# TECHNICAL INFORMATION

63829

- Subject** ▶ Change of Flat Washer 8 and Pan Head Screw M6
- For Models** ▶ LC1230
- Country** ▶ All countries
- Description** ▶ 2 each of Flat Washer 8 and Pan Head Screw M6 have been changed as illustrated below.

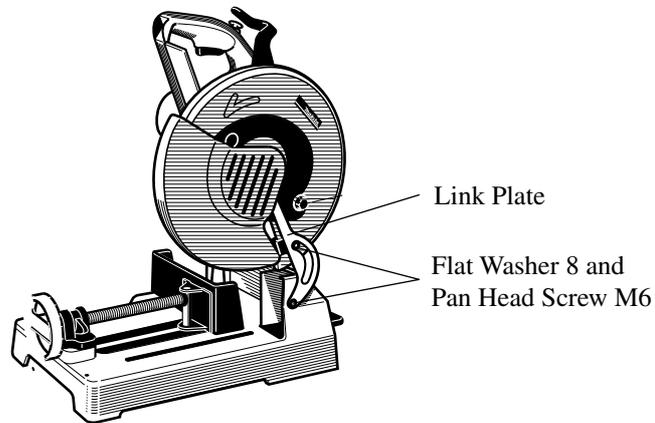
▶ Current	▶ New
Flat Washer 8	 <p>Thickness: 0.5mm</p>	 <p>Thickness: 3.0mm</p>
Part No.	25139-0	267236-6
Pan Head Screw M6	 <p>5.0mm</p>	 <p>7.5mm</p> <p>Higher head than the current</p>
Part No.	251331-2	265089-7

Item No.	Current part	Q'ty	I/C	New part	Q'ty	Note
092	Flat Washer 8 25139-0	2	No	Flat Washer 8 267236-6	2	↑ Interchangeable as a set ↓
093	+ Pan Head Screw M6 251331-2	2	No	+ Pan Head Screw M6 265089-7	2

From serial No.16722K (June,2001)
